Village of Shorewood Hills University Avenue Corridor Plan Public Meeting #3 Responses

Introduction:

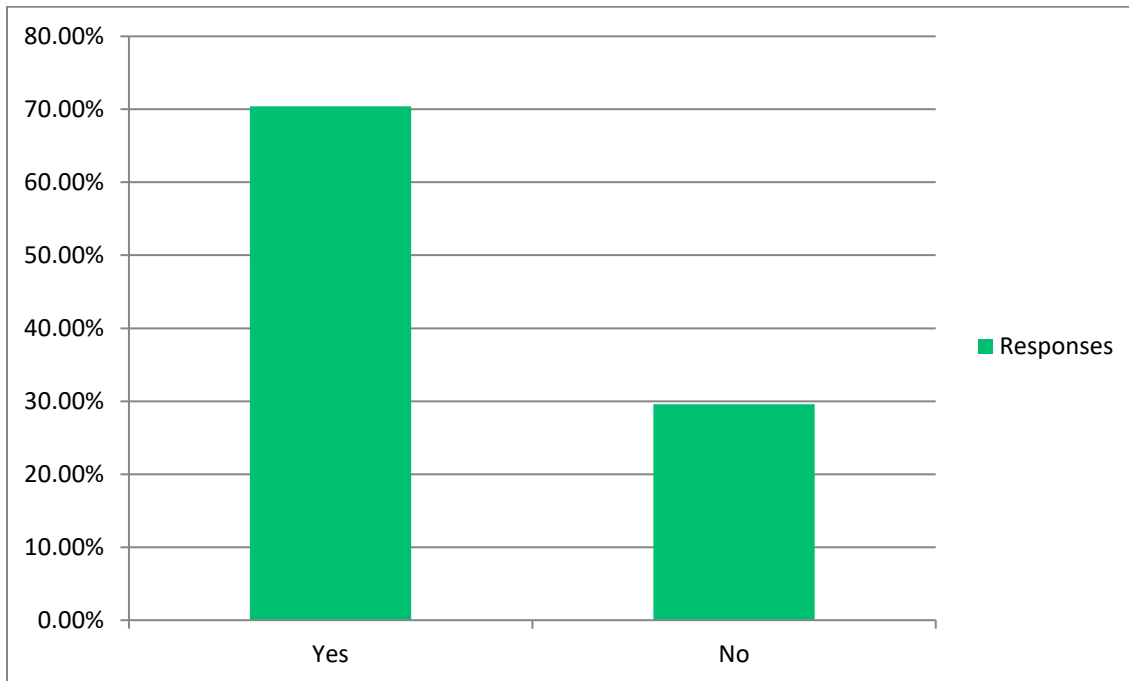
Subarea 1
<ul style="list-style-type: none"> • Handicapped accessibility of close surface parking • Ok • Reduce surface parking • Improve bike/pedestrian path crossing Marshall Court. Reduce parking in front of buildings. • Mix of housing and parking • increase density targets • I don't know • Increased green areas, make this safe for the kids living here • Fine as proposed • Needs better connections to Harvard Dr - the people in the neighborhood to the north will likely go nuts about it, so we may have to settle for ample bike/ped connections • no more than three stories. This is a residential neighborhood!!! • Strongly considering lowest height possible buildings so that University Avenue does not become a sunless, narrow corridor with little appeal for pedestrians. • Buffering from redevelopment • Marshall Ct. traffic is already dense and difficult • Should be limited to 3 stories • Ability to safely cross south on University Avenue as biker or pedestrian • Mix use residential and commercial. 5 stories too high. Like underground parking. Problem is 5 stories, 4 should be max. • Reduce surface parking • Protecting/buffering the residential area on. The north and east sides. • Marshall Ct is already too congested with bldgs • Restrict to 3 stories • maybe the town hall could go here? • Closest to existing Shorewood homes: avoid destruction of existing greenspaces and sound barriers between new development and existing homes! • Transportation, etc. • Should revisit entrance to pool parking thru this area • Traffic and parking • walking and park space connections most important • 6 Principles apply well here, in the order they are presented.

Subarea 2
<ul style="list-style-type: none"> • Too dense. No green space. Concrete jungle • Do not reduce set-backs from street. This is primarily residential • Gathering spaces • Reduce surface parking along U Ave. Improve/widen ped/bike paths through zone • Noise, sustainability, low buildings, owner-occupied spaces • increase density targets, no ped bridge just reduce danger to pedestrians at ground level • pedestrian bridge is a good idea • Green space connectivity. This has great potential for central gathering • Fine as proposed

- Sidewalks on both sides of all streets (including Locust). Much less surface parking!!! Village Hall site should be redeveloped
- Building height, green space, density

- ignores that likelihood of parcels becoming available for development are miniscule
- Pedestrian bridge to the south - it does not feel safe crossing University

- No skyscrapers please.
- Strongly considering lowest height possible buildings so that University Avenue does not become a sunless, narrow corridor with little appeal for pedestrians.

- Potential pedestrian bridge
- reduce to 4 stories max, with condos, consider traffic mitigation on Locust
- Ability to safely cross south on University Avenue as biker or pedestrian

- Like green space, mix residential and commercial, like 3 stories and underground parking.
- Reduce surface parking
- Can you reasonably do this with the UW controlling a large portion of the area.

- No 8 story tall bldgs in this area lower stories ok, i.e. <4 stories
- Keep the internal area appealing and exposed to the sun - have shops that people are almost sure to use, not, as often happens, something trendy or so quirky as to be of little use. Shops like those in the minimal where Ancora now is -- character and utility. The buildings must not be boring and the interior can not be stifled by shade. For people

- 2 and 3 should be connected; town hall should be easily accessible to corridor and tradition village residents. Its current position is optimal; if that is not big enough, consider expanding next to the fire station

- A protected multi-use path along Locust Dr
- Bike/walking lanes and access
- Transportation, building mix
- Main focus should be on housing not little used office buildings with big surface lots. If underground parking too expensive can also consider how townhouses on Midvale use and hide ramp parking

- social gathering areas (restaurants, parks, etc.)
- Traffic, parking, green space, lower height buildings
- as someone with kids, I wonder if the pedestrian bridge would be most important to draw people from south of University

- 6 Principles apply well here, in the order they are presented.

- Poor handicapped accessibility to none.
- ok
- Increase green space
- Expand Subarea 3 to include vacant land in Garden Homes
- Traffic flow
- increase density targets
- Bike/walk to Madison Yards?
- Less asphalt more water storage for flash flood events
- Fine as proposed
- Needs improved access between the bike trail/locust Dr and Hilldale/Target
- current largest property owner will not be allowed to build as he sees fit
- This area was just built.

- Subarea 3 should be left alone because it welcomes a beneficial fresh population to the area as it is.
- Strongly considering lowest height possible buildings so that University Avenue does not become a sunless, narrow corridor with little appeal for pedestrians. This area will look like and lead to people speeding through the area.

- Increased green space
- consider traffic mitigation on Locust
- Ability to safely cross south on University Avenue as biker or pedestrian
- Like green space, mix, would rather see 3 than 4 stories, like underground parking.

- Reduce surface parking
- Seems a little early to be redeveloping this area. It was developed with a great deal of agony. It may be time to give it a rest.

- ok as depicted
- 2 and 3 should be connected
- Building mix, transportation
- McDonalds wastes a lot of space
- can we include the two streets of partial housing to the east of this?

- Traffic, parking, green space, lower height buildings
- not sure, maybe commercial is important here, to expand the usable walking space
- N/A (re this area has been redeveloped recently, except McDonalds).

- Poor to none handicapped accessibility.
- 8 stories is too large. Do not allow large scale redevelopment. Undesirable for taller buildings to cast shade on the golf course, which is used for golf and, in the winter, for winter activities.

- Mixed use of commercial and residential area
- Leverage views over golf course to Lake - highest rise building?
- Traffic flow
- increase density targets

- increase green space and gather flash flood water
- Fine as proposed
- The poor connectivity of subarea 4 due to the University Ave bridge and Old Middleton Rd exit make it a very bad location for mixed use/commercial. It should be just residential - one or two Weston Place-like towers.

- prevent land grab by University or affiliates
- Where else are you going to store the salt, water system parts, etc?
- 8 story buildings are too tall for this area and will lead to the feeling and appearance of University Avenue as a narrow, sunless corridor to somewhere else.

- Increased green space
- reduce to 4 stories max, with condos, consider traffic mitigation on Locust
- Ability to safely cross south on University Avenue as biker or pedestrian

- Like increased green space, 8 stories seems very high and cavernous (but understand the concept of nice apartments looking to lake --still seems very high and daunting to homes behind it). Like everything else.

- Need lots of height
- This area has the ugliest buildings in the village. Any sensible development would be an improvement.
- ok as depicted

- this zone seems very isolated
- The village storage building is so ugly the architect should lose their license. Should work with state to see if crime lab site can be moved and this whole area could be high rises with connection to hilldale/madison yards
- Can we work with the state to relocate the crime lab and pull that land into this planning?
- Like the idea of high rise living in Shorewood hills. Gives aging residents options to stay in the village but not have the maintenance a home requires. Should be owner occupied. There is plenty of rentals going up and very little owner occupied
- Green space
- all sounds good!
- N/A (re should not be a focus of this exercise for the Village, unless the State plans to sell its large parcel immediately east).

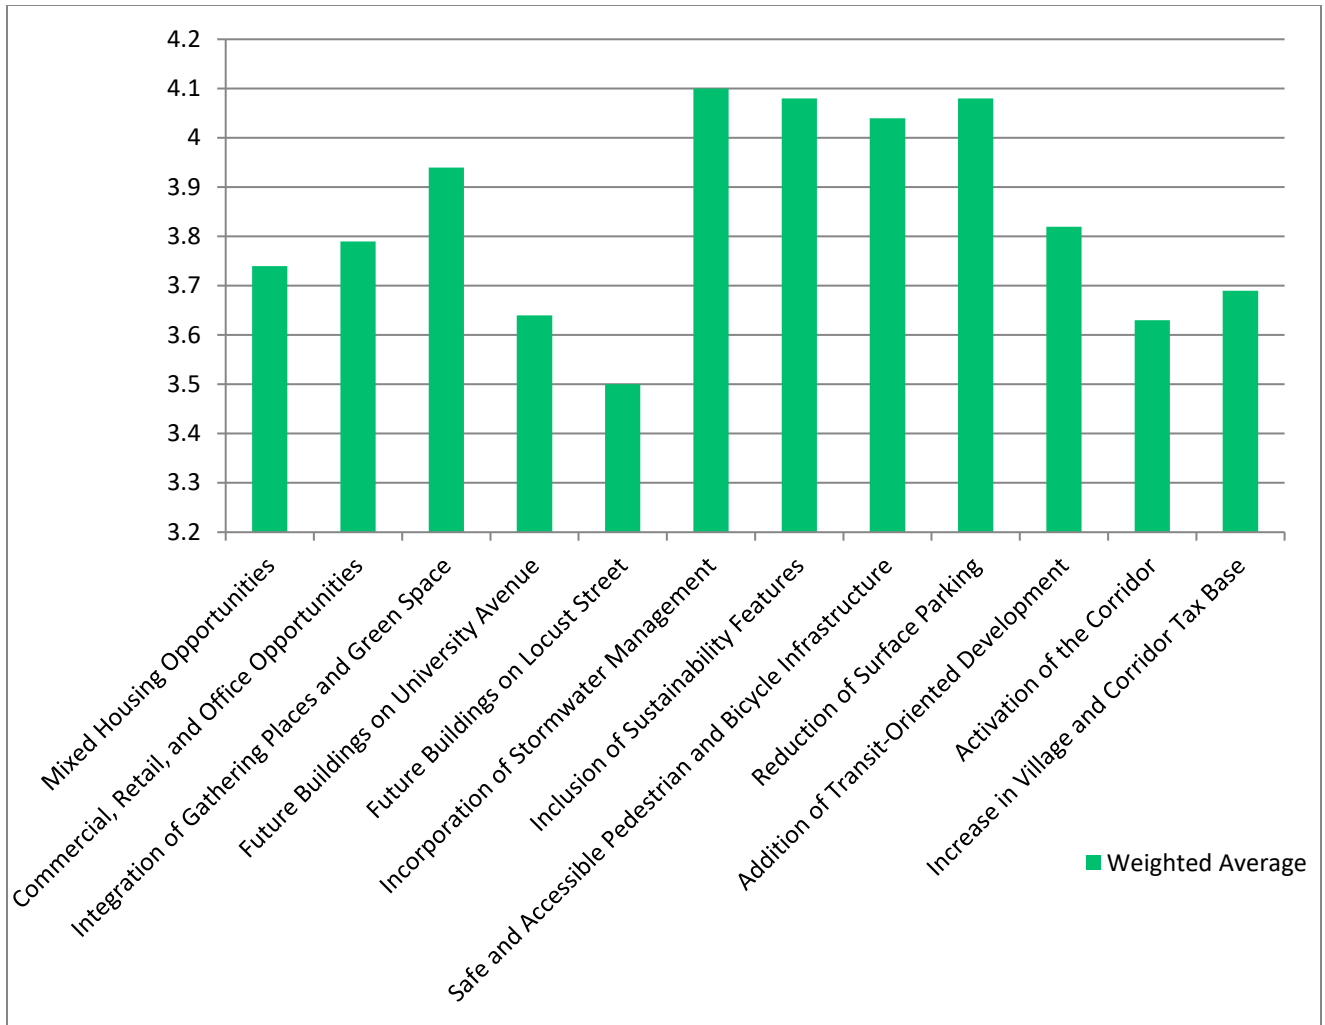
40 Written Comments Received
Providing more handicapped accessibility, more green space, more environmental friendly design and architecture.
Reducing the max height from 8 stories to 5 stories.
Signalized train crossings throughout corridor to enable reduced use of train horns
Designated pickle ball courts
Lower building
1) I realize Garden Homes was not included in this study. But why no planning for the Walgreens/Metro Mart/Janets/UWCU area? Seems important to consider potential development there, particularly since the area between Highland and Joyce Erdman may never be redeveloped (since it is/will be owned by UW).
2) Give extra (extra!!!) positive consideration/funding to any development that would coordinate with a future development across University Ave that would allow the construction of a PUBLIC PEDESTRIAN OVERPASS over University Ave.

<p>3) Require a PILOT if any property in the area is developed by a tax exempt entity (other than Shorewood Hills municipal government).</p> <p>4) The SW corner of Shorewood Blvd and Locust seems prime for a smaller commercial development. Should that be allowed there? i.e., consider reconfiguring the "Redevelopment Site" plan east of the proposed housing facing Locust to include that.</p> <p>5) In the future, consider moving all Shorewood Hills municipal government functions to somewhere in this University Ave. area (and sell the DPW building at 1008 Shorewood Blvd for the development of owner occupied townhouses there). To facilitate this consolidation, increase the value of the Village property at 810 Shorewood Blvd by allowing a commercial development to replace Village Hall on that corner, per Comment #4 above.</p> <p>6) Require future walking paths through developments be open to the public (i.e., prohibit closed access as presently is the case at Shackleton Sq). Further, require that all "green" and "gathering spaces" are accessible to ALL residents, not just tenants of the developments (e.g., the spaces envisioned as "E" (roof terrace) and "I" on the site plan would be accessible to all).</p> <p>7) Install a sidewalk on the south side of Locust and improve the bike trail on north side of Locust.</p> <p>8) Give extra positive consideration/funding to any development that features owner occupied and affordable housing.</p> <p>9) Re question #9 below, I would support the concept with these comments considered/incorporated.</p>

<p>Thanks for considering these thoughts.</p>
<p>increase density. I don't see any bike/ped stuff except for some private paths, the paths on locust should be improved. Add public gathering spaces (all the ones shown look like they are owned by private landowners - that's not public). Reduce surface parking further. Make the buildings taller.</p>
<p>Details are unclear about safety, sustainability, and specifics of mixed use so difficult to give input.</p>
<p>Dog park would be nice</p>
<p>prioritizing pedestrian travel over vehicular travel. We will be changing from an everyone needs a car to that of a car is a bother and an excessive hassle. Cars will be electric and garages are spaces no longer cut off because of gasoline hazards. Can residence trade a parking space for a mobile raised garden?</p>
<p>E-W street connection between Highbury and Joyce Erdman Pl</p>
<p>Incorporating views of younger home owners not represented in current surveys</p>

<p>See comments for #2-#4</p>
<p>being realistic as to which sites could potentially become available for re-development, for example: UW Extension bought UW Credit Union, won't demolish office bldg and re-develop as housing</p>
<p>Townhouses too uniform. Have some with one-car garages. Vary the fronts.</p>
<p>Is it possible to increase the green roofing? Or mandate solar panels?</p>
<p>There is great opportunity for stormwater management with enhancements such as bioswales, underground cisterns, etc. Also green roofs where possible. Same with sustainability features. Good solar exposure, perhaps grey water collection, etc.</p>
<p>Alley could have pervious pavement</p>
<p>Less uniformity on Locust</p>
<p>Reduce the building footprint overall so that true greenspace could increase. The parking structures will make a bigger impact in person/reality than seems when looking at the plans. Not build 8 stories.</p>

<p>C is too tall! Activation of the Corridor is developer-speak, what does that mean? Like the green roof! Vary "H" so its not a wall. H should have underground parking to lower the height.</p>

single family residential like the original conception of the Village
Reducing parking minimums so developers don't have to spend large amounts on underground ramps.
Lower level buildings seem more aimed at maintaining the character and quality of the area.
You show a very spacious activated University Ave development area in the cross section. Is that to scale with what is shown in plan? Again, I won't answer the Question #9 in the affirmative because I don't think its appropriate to ask a respondent to vote all in at this time.
Keep university ave buildings under 5 feet
Reducing 8 stories to 4, including owner-occupied condominiums, considering how to mitigate traffic on Locust
Incorporating bike parking (probably will be included but it is not designated on the map)
Safe and Accessible Pedestrian and Bicycle Infrastructure
Only question is 8 story building? See earlier comment.
This is great. Much better than the existing use.

No 8 story bldgs in the Redevelopment Site, keep bldgs to <4 stories
Do not have series of 8 story buildings that all look the same. That will kill the place and the shops that might be there. Make heights vary, as well as the architecture. Do not contribute to the disastrous construction of boxes all over Madison. The village still has a very special feel.
Keep the village offices on the ground floor and easy to access.
A protected multi-use path along Locust Dr
I do not like the 8-story building idea.
I think some green space is nice but the area could be move densely developed relying more on existing neighborhood green space and green roofs. Also townhouses should have two distinct targets young families who can use elementary school but can't afford houses in village and seniors wanting to downsize but stay in village but probably want higher end condominiums townhouses. Getting some to move within the village would also help expand supply of family homes in village for younger families. Again housing is way more important than office

I do not think it is a good idea to create office space. It is shrinking and will only continue. We should be focusing on retail and residential. If we are going to have parks for gathering, we need to have something to bring people there (sports, restaurants, etc.)
No large scale building as far as height. We are ruining this city by all of these huge buildings.
Dog park
creating more connection among green spaces - an archway creating a walking path under buildings that otherwise block the corridor (e.g., the vertical section of building D) - allowing people to move more freely among commercial and green spaces
The Village should take this opportunity to take a serious look at a concept that would improve the east/west bicycle lanes on Locust; since those bike lanes were installed when Locust was reconstructed 24 years ago, bike traffic along that corridor has greatly increased; perhaps the bike lanes need to be wider? separated from vehicle traffic? etc.
